In the Matter of Petition of WorldCom, Inc.)	
Pursuant to Section 252(e)(5) of the)	
Communications Act for Expedited)	
Preemption of the Jurisdiction of the)	CC Docket No. 00-218
Virginia State Corporation Commission)	
Regarding Interconnection Disputes)	
with Verizon Virginia Inc., and for)	
Expedited Arbitration.)	
)	
)	
In the Matter of Petition of Cox Virginia)	CC Docket No. 00-249
Telecom, Inc. etc.)	
)	
)	
In the Matter of Petition of AT&T)	CC Docket No. 00-251
Communications of Virginia Inc. etc.)

**SUPPLEMENTAL REBUTTAL TESTIMONY OF
FRANCIS J. MURPHY
ON BEHALF OF
VERIZON VIRGINIA INC.**

November 16, 2001

1 **Diagram - SONET OC-48 Pass-Through Effect on Adding and Dropping DS-3s**

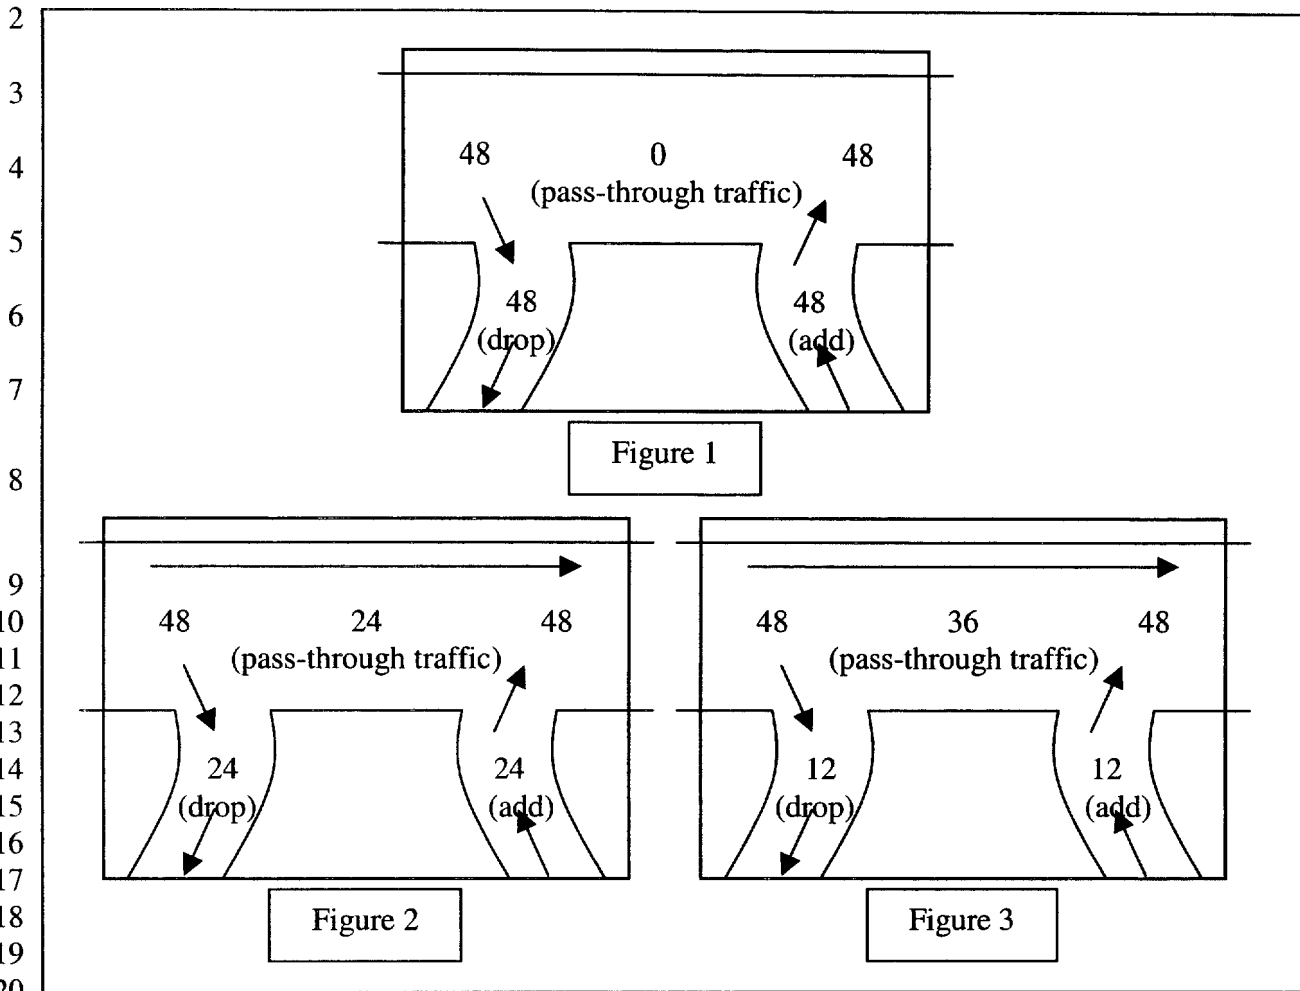
11 **Q. Can you demonstrate the impact of passing through nodes on a SONET**
12 **ring?**

13 **A.** Yes. The following diagram illustrates the impact of traffic passing through
14 nodes on the number of DS-3s that can be added or dropped at each node. Figure
15 1 of the diagram below shows that with no pass-through traffic (essentially a point
16 to point configuration), 48 DS-3s can be added or dropped at a given node.
17 Figure 2 of the diagram shows that with 24 DS-3s passing through the node, the
18 maximum number of DS-3s that could be added or dropped at the ADM would be
19 24. Figure 3 shows that with 36 DS-3s passing through the node, the maximum
20 number of DS-3s that could be added or dropped would be 12.
